MMO Reference: DCO/2016/00005  
Planning Inspectorate Reference: EN010078  
Interested Party Identification Number: 20024119

**Planning Act 2008, Scottish Power Renewables Limited Proposed East Anglia Two Offshore Windfarm Order**

**Relevant Representation**

This document comprises the MMO’s initial comments in respect of the DCO Application in the form of a relevant representation.

### Herring larval abundances in the Southern North Sea during each of the three IHLS surveys (ICES 2014)

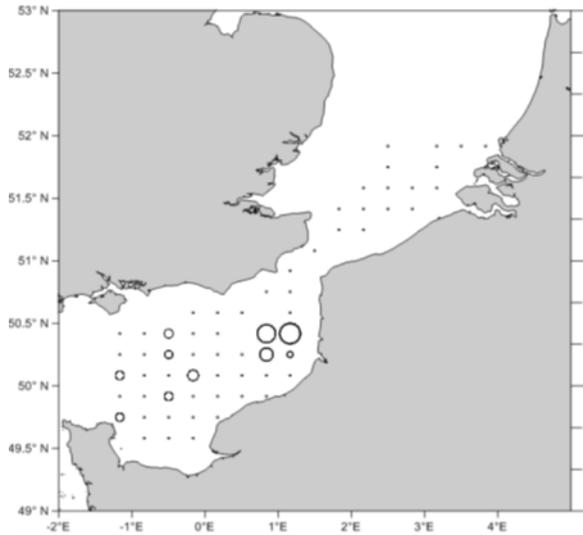
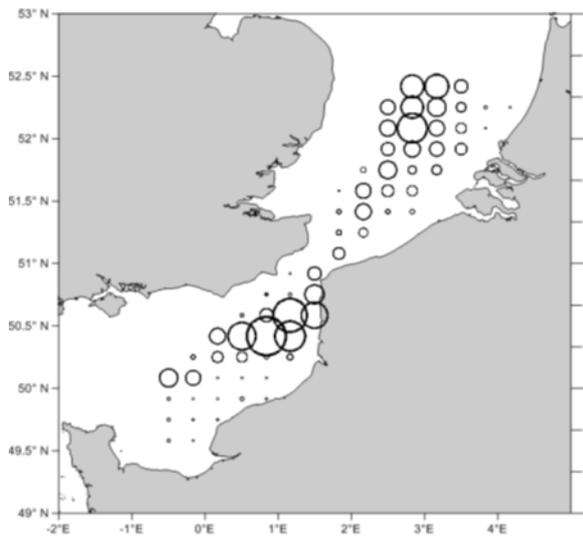
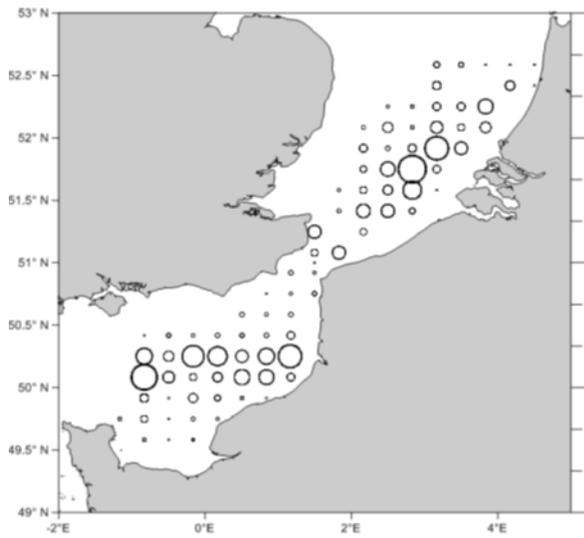
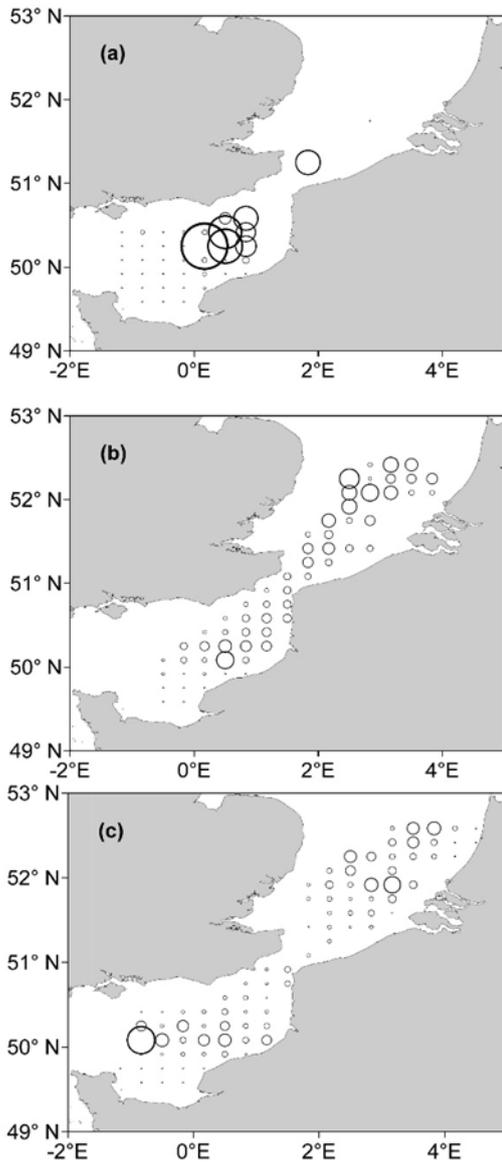
- 3.4.7 It is understood that Downs herring spawning activity in northern parts of the spawning grounds occurs later in the season compared to those grounds further south in the English Channel, please see Annex 1 for examples of this taken from ICES (2014 and 2016) which demonstrate the variations in larval abundance according to the periods in which surveys were carried out. With this in mind, the MMO recommend that mapped noise contours should be overlain over 10 years of IHLS data which has been consolidated by IHLS survey period (i.e. 16-31st December 2008-2018, 1-15th January 2008-2018 and 16-31st January 2008-2018).
